## Minutes of a meeting on vacuum aspects of the PS/RF 40 MHz (LHC) prototype cavity (PE-2232/LHC/PS, IT 2232/LHC/PS)

Date: Wednesday, 5 October. 1994

aim: Clarification of vacuum requirements for the 40 MHz prototype cavity.

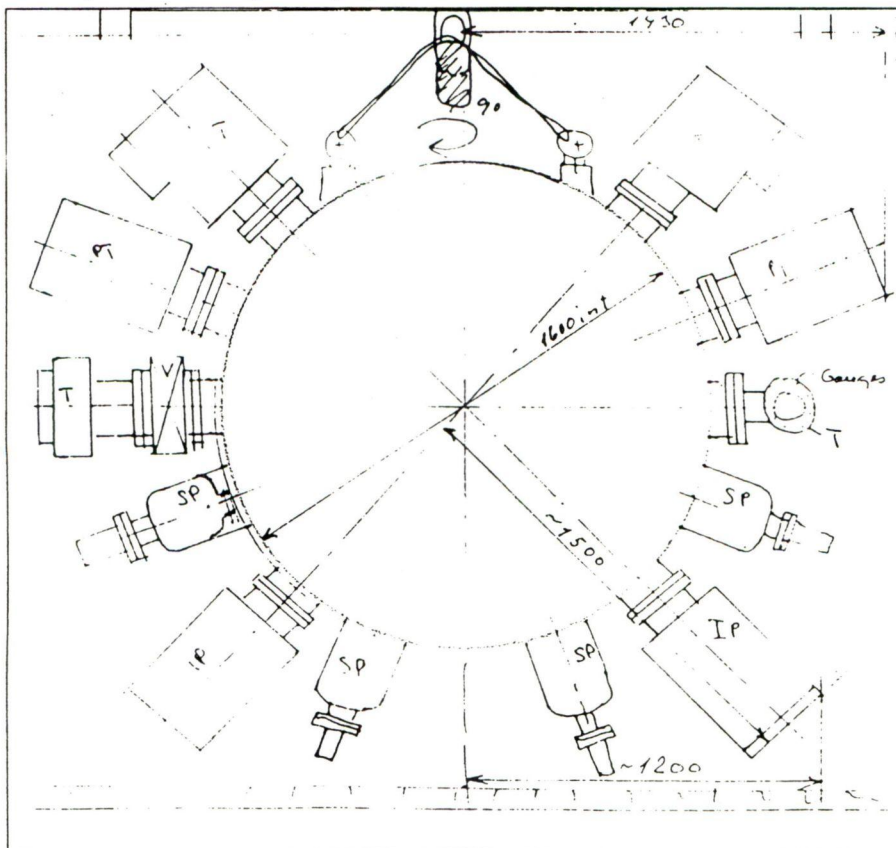
Sten Milner pointed out that it would be impossible to transport the cavity through the PS tunnel and position it in the ring with the large ion pump units on it. For this reason, and to gain on the pumping efficiencies mentioned above, he proposes a different scheme where no elbows are used and all pumps are mounted directly onto the cavity. The proposal is sketched in Fig. 2.

The proposal was generally approved by the vacuum experts. E. Jensen will have to estimate the diminution of the Q factor of the cavity by the large number of openings in the outer cavity wall.

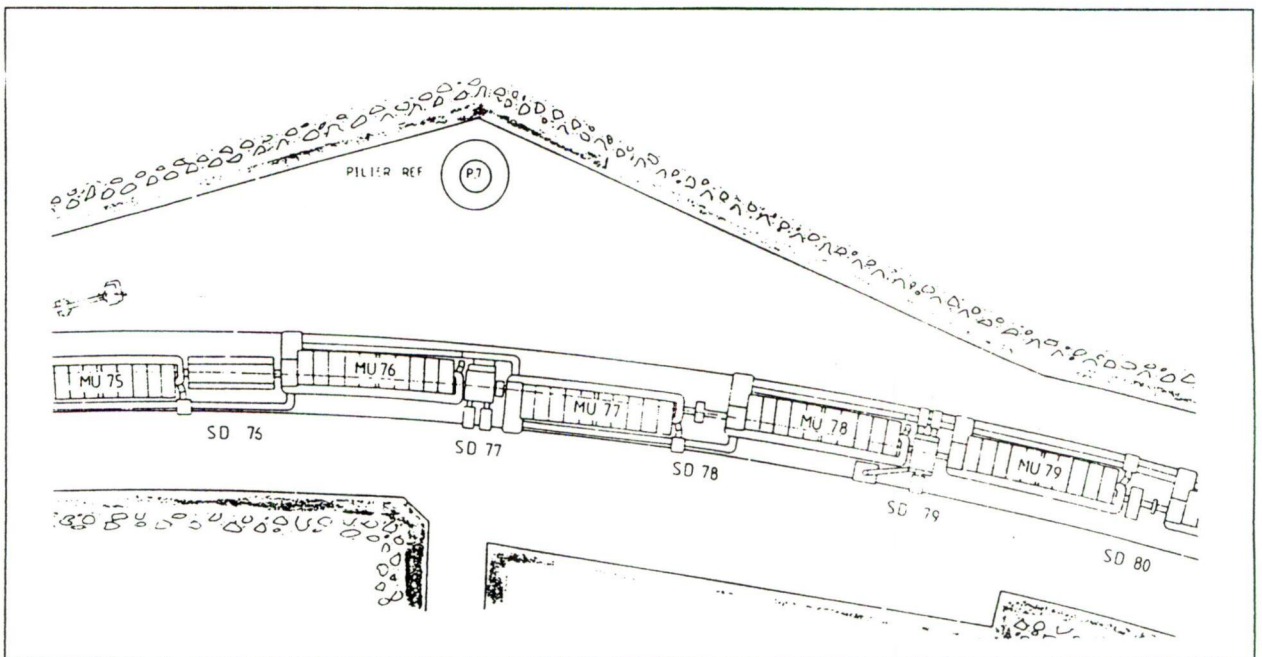
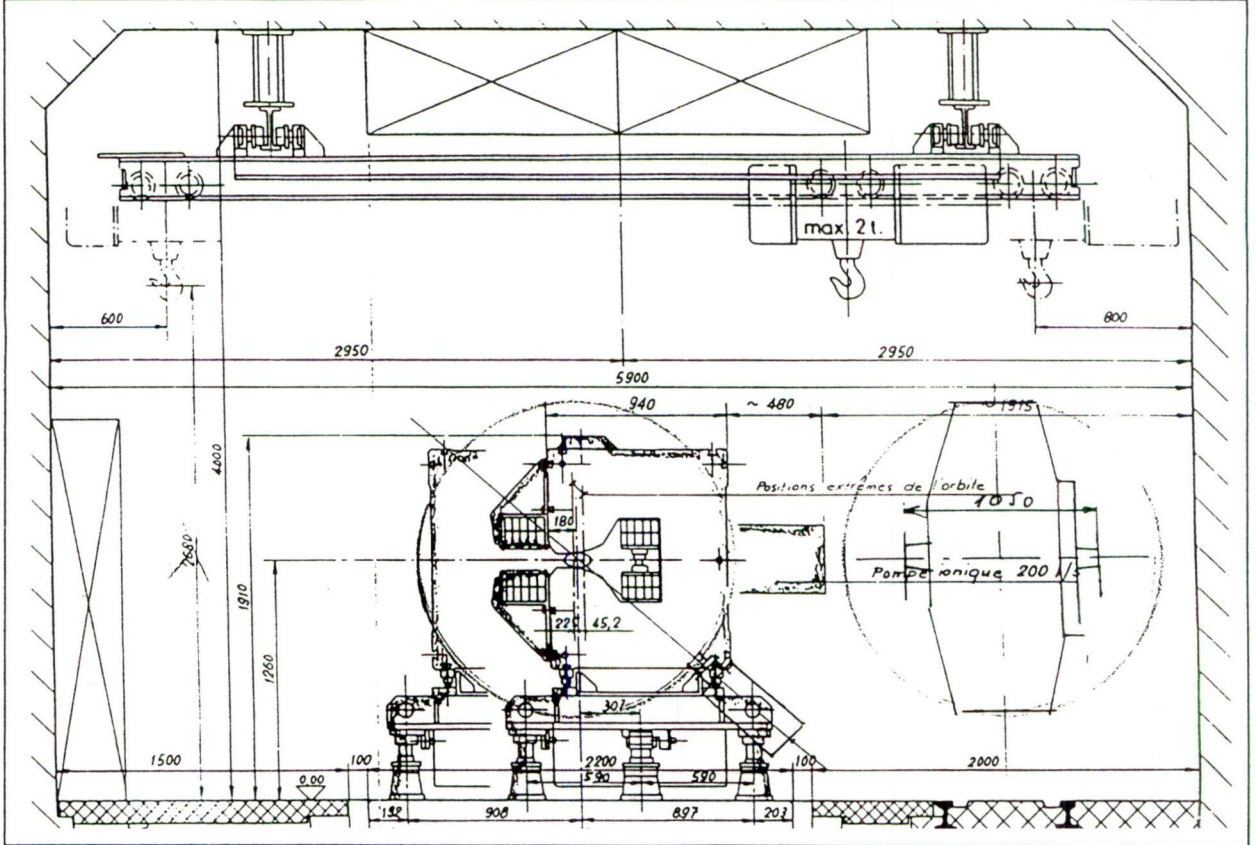
Even with this (slim) construction, the possibility to transport the cavity through the PS tunnel has to be verified in detail (cf. Fig. 3). There is a niche at the inside of the tunnel near SD77 and SD78 (cf. Fig. 4), but it must be checked during the shutdown in week 43/44 whether this is usable.
